APPLICANT: GE Nuclear Energy (GE)  
FACILITY: Advanced Boiling Water Reactor (ABWR)  
SUBJECT: SUMMARY OF MEETING HELD ON MAY 1, 1996, TO DISCUSS CHANGES TO THE DESIGN CONTROL DOCUMENT (DCD) FOR THE GE ABWR

*Guidelines for Pre-Certification  
Design Changes to the ABWR Design*

***Proposed Changes to ABWR Design Control Document***

**Change Package No. 1**

FIGURE 9.4-3 SECONDARY CONTAINMENT HVAC SYSTEM (Sheet 1 of 3)  
 ABWR DCD/Tier 2 Rev 0 21-542.1

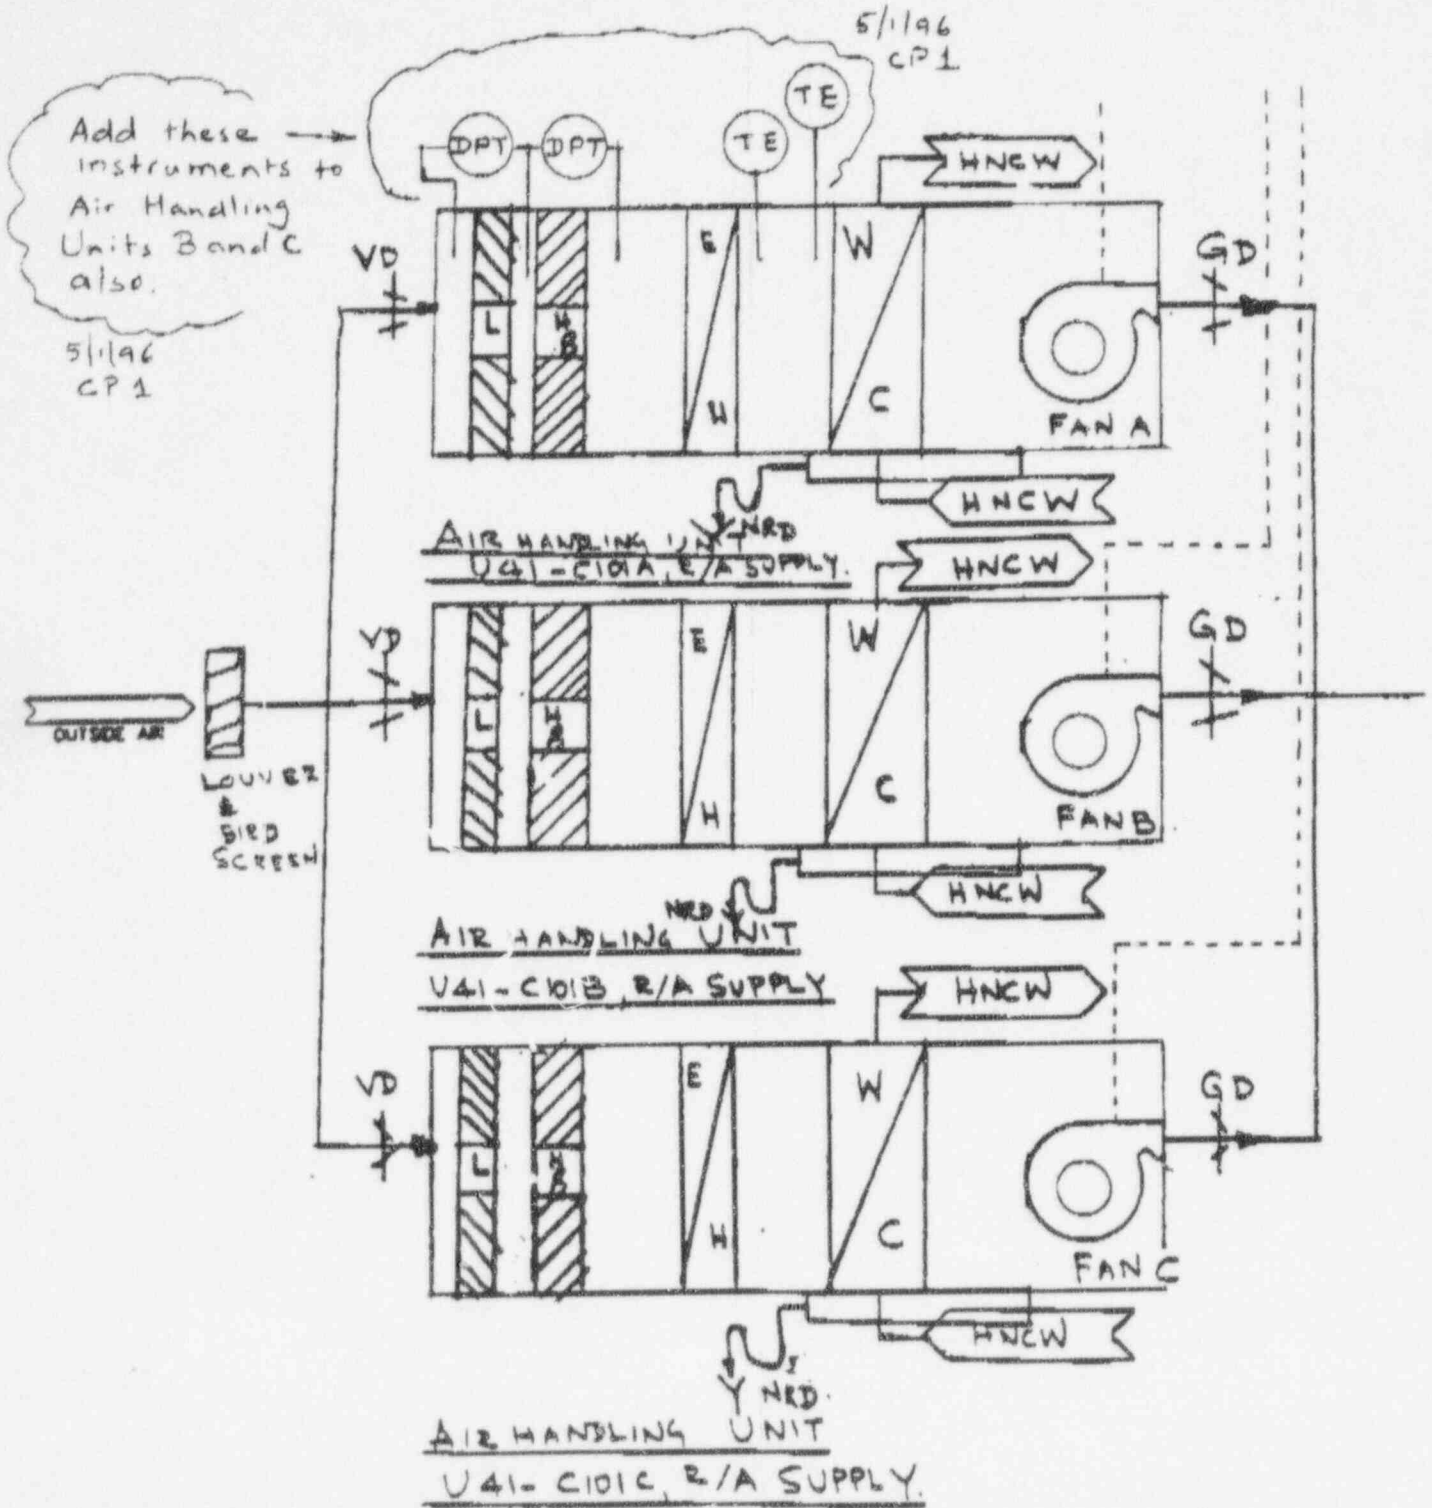
- ***Change the Smoke Removal Method for Three HVAC Systems (for RB-SREE, CRHA and CB-SREA)***
  - ***Comply with the accepted method prescribed by the industrial standards (ASHRAE and NFPA)***
- ***Replace centrifugal fans with vaneaxial fans as necessary for space conservation***
- ***Service FMCRD Panel Rooms from Divisions A and B of RB-SREE HVAC system, instead of Divisions B and C***

- ***Positive exhaust ventilation method is preferred rather than pressurization method of smoke removal from rooms served by HVAC Systems***
  - *Include dedicated smoke removal fan in RB-SREE HVAC System*
  - *Activate both exhaust fans of CRHA and CB-SREA HVAC Systems*
- ***Distribute cooling load evenly by assigning FMCRD Panel Rooms to Divisions A and B***
- ***Reconfigure ductwork to allow single point cross-connect from return to exhaust ductwork except for Rooms of DGs, day tanks, chillers and batteries having direct exhausts***

#### 9.5.13.10 HVAC Pressure Calculations

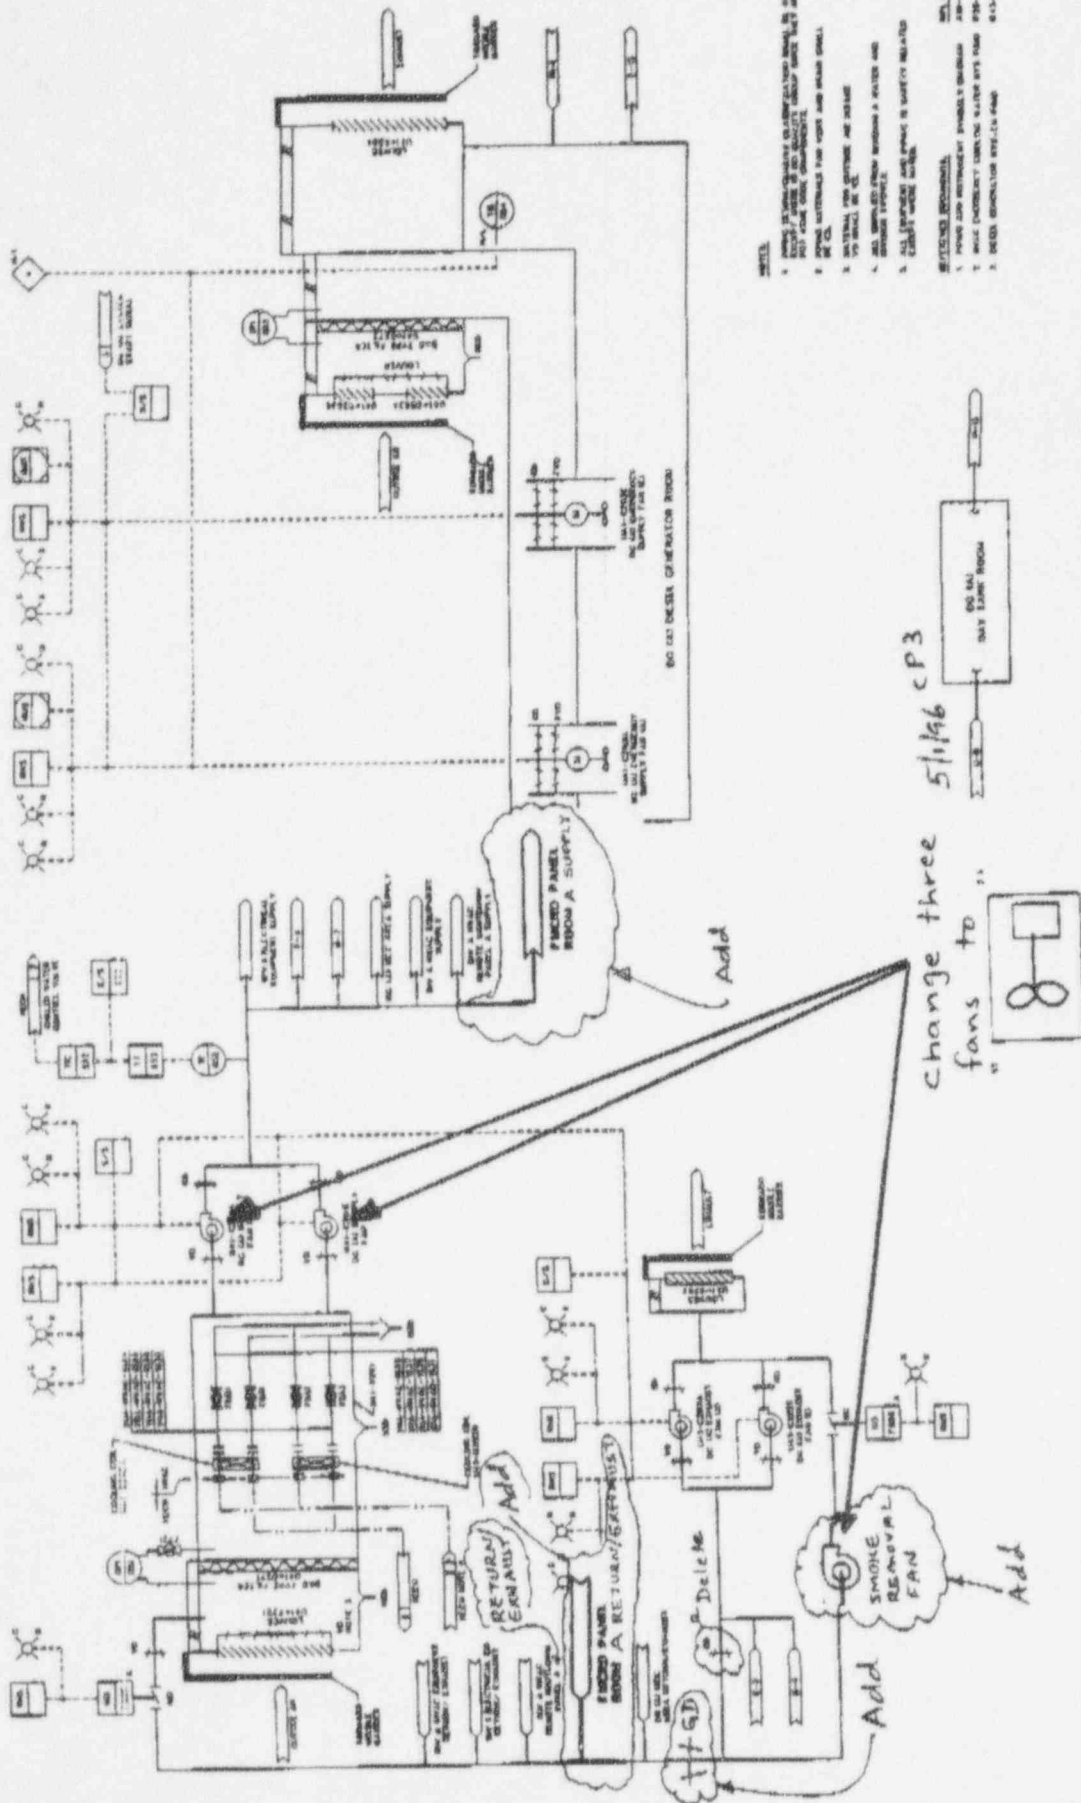
*not used*

The COL applicant shall provide pressure calculations and confirm capability during preoperational testing of the smoke control mode of the HVAC systems as described in Subsection 9.5.1.1.6.

FIGURE 9.4-4 R/B SAFETY-RELATED ELECTRICAL EQUIPMENT HVAC SYSTEM (Sheet 1 of 3)

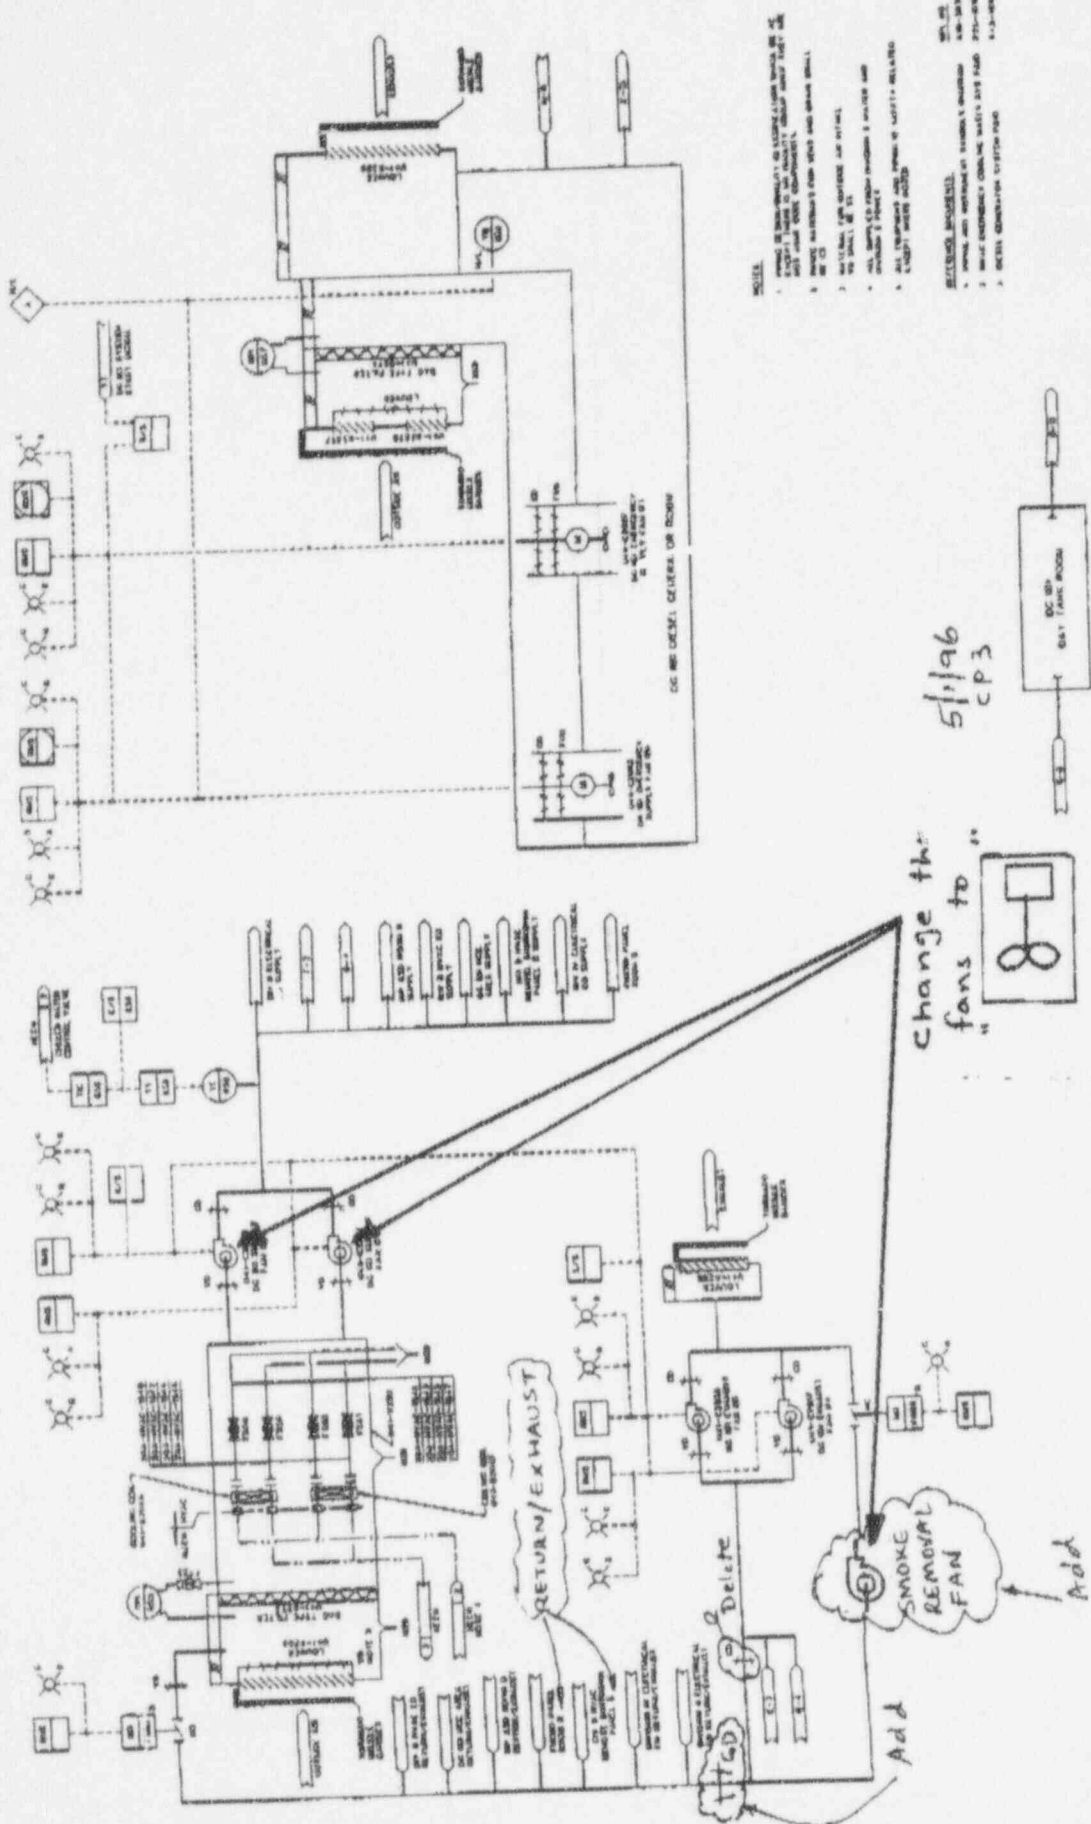
change the fans to "8"
